Job Sheet 216585

Part Name: Strut Bracket

DART 3030 ENTERPRISE CT., SUITE A
 AEROSPACE VISTA, CA 92081
 APICAL INDUSTRIES, INC. (760) 724-5300
 SHEETMETAL BRACKET
 REV. N/C
 07/02/19
 654.1000

From: Alex Quan
Sent: Tuesday, December 15, 2020 2:20 PM
To: David Duval
Cc: Jean-Luc Menard; Ernesto Navarro; Tori Sera; Jacob Becker
Subject: RE: New Product
Attachments: 654.1011 NC.dxf

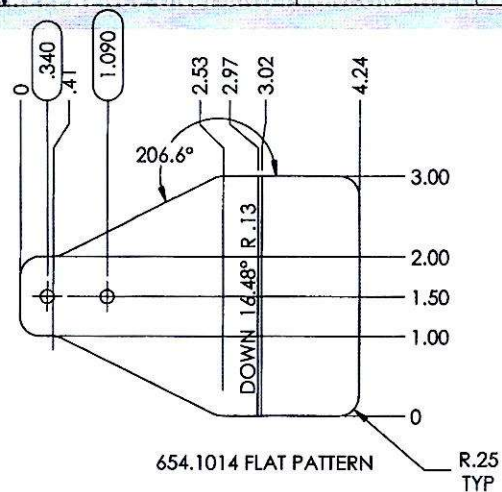
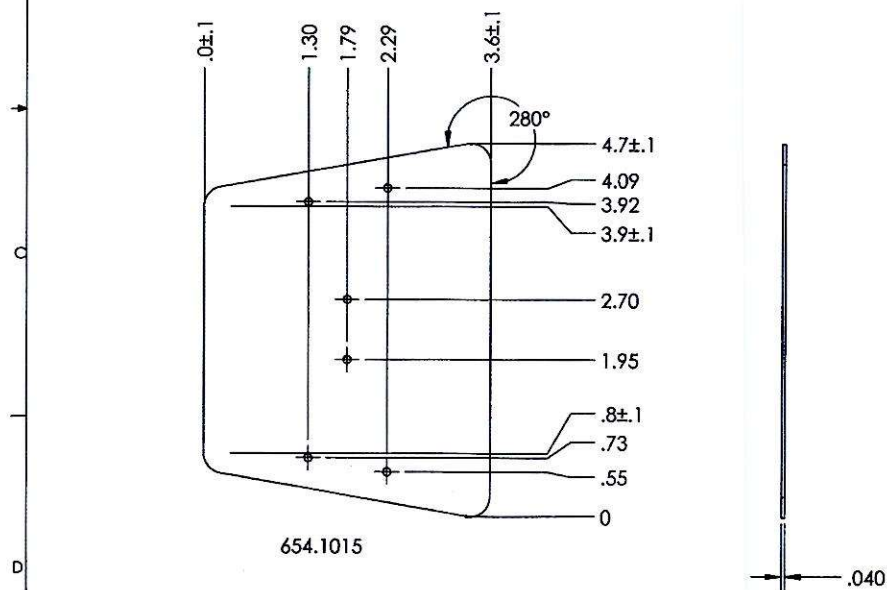
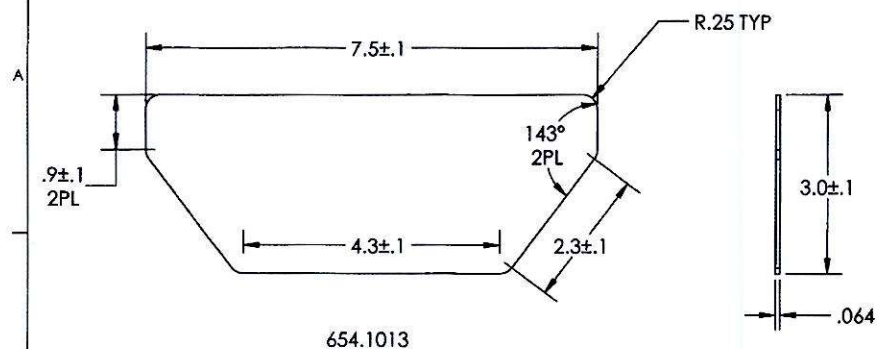
Hi David, from the models I see that the holes for the 654.1014 are 0.170" dia, and the holes in the 654.1015 are 0.098" dia.

On Dwg 654.1000, missing hole dimension on 654.1014 and 654.1015.

I'll have to submit an ECR to update the drawing. Not sure how fast it'll take to get that updated.
